SHEET SIZE= C	DRAWN BY: F.S.B.	PART NUMBER or STYLE:	
SCALE = 1":1"	DATE DRAWN:	C10 7ft Stair Section	
STANDARD TOLERANCE:	2/11/2015	Quote requested by:	
.00 ±.01 FRACTIONS:	LOC:	Z:\Aluminum\Westbury\C10	
.000 ±.005 ±1/8"	Tuscany\Section\Stair	PART NAME:	
ANG. ±.5°	FIRST USED ON:	C10 Tuscany	SHEET REV.
	DRAFT:	of	B
	20141001-5F

DSI Digger Specialties, Inc. 3446 US 6 EAST Bremen, IN 46506

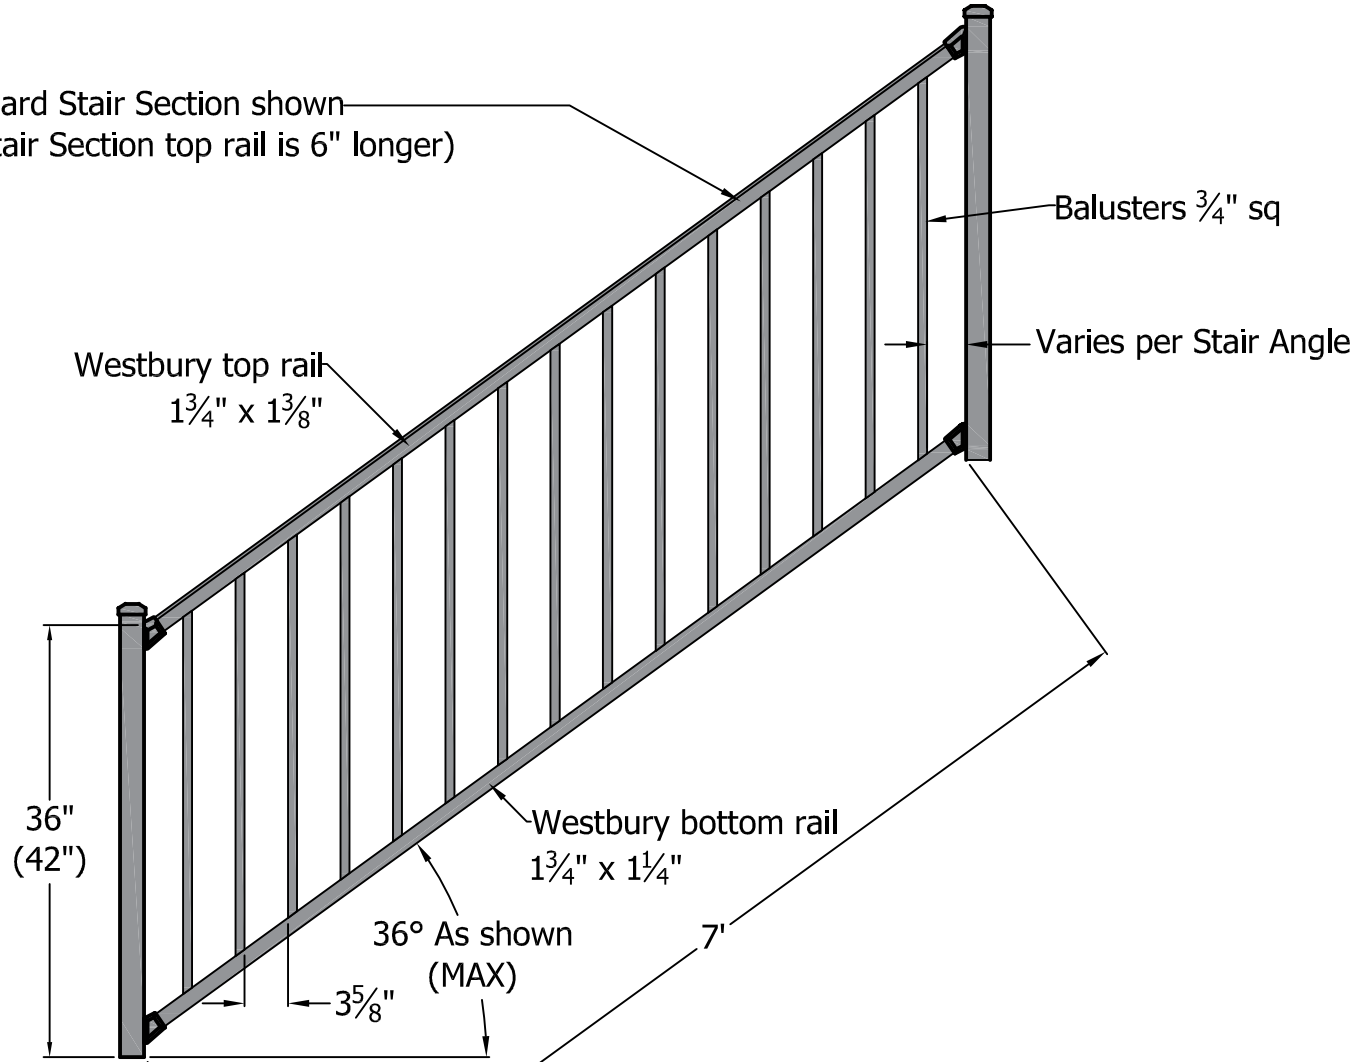
REV.	LOC.	REVISION	DATE
A		RELEASE PENDING APPROVAL	
B		Baluster spacing 3.625. Increased hole size to accomodate 36° stairs.	2/11/15
